SUBJECT: Campaign #128 – Range Enclosure

INSTRUCTION TO PERFORM CAMPAIGN #128

INSTRUCTIONS TO PERFORM CAMPAIGN 128

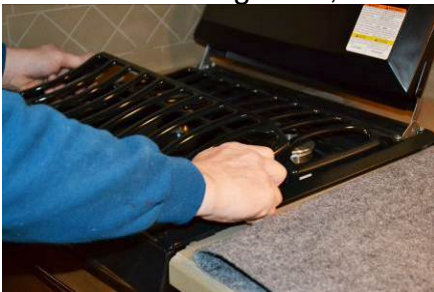
1. Shut off the LP gas on outside of coach.

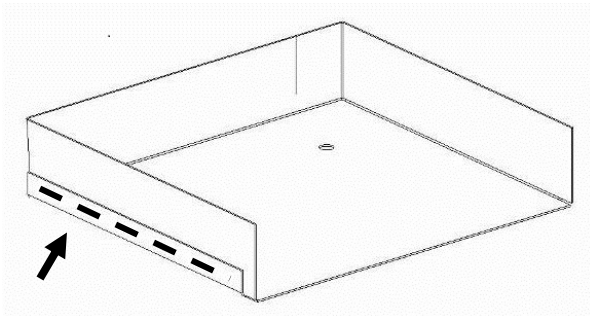
5. Using a 5/8" and 13/16" open-end wrench, loosen and disconnect LP gas line.

**Atwood &
Suburban Range
Enclosure**

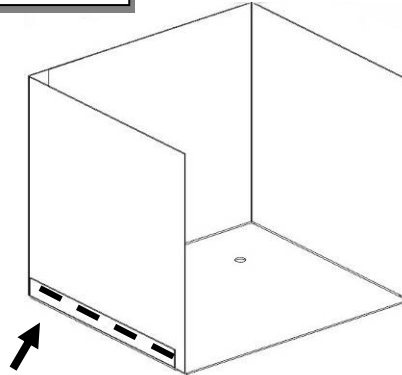
7. Using the perforated lines, fold the stove enclosure into rectangular position and staple to hold shape, making sure the outer lip is stapled to the outside of the stove enclosure.

Staple along this
edge.

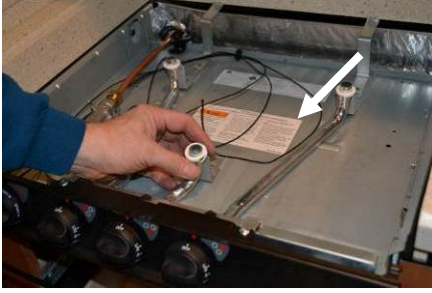
11. Reconnect LP gas Line.
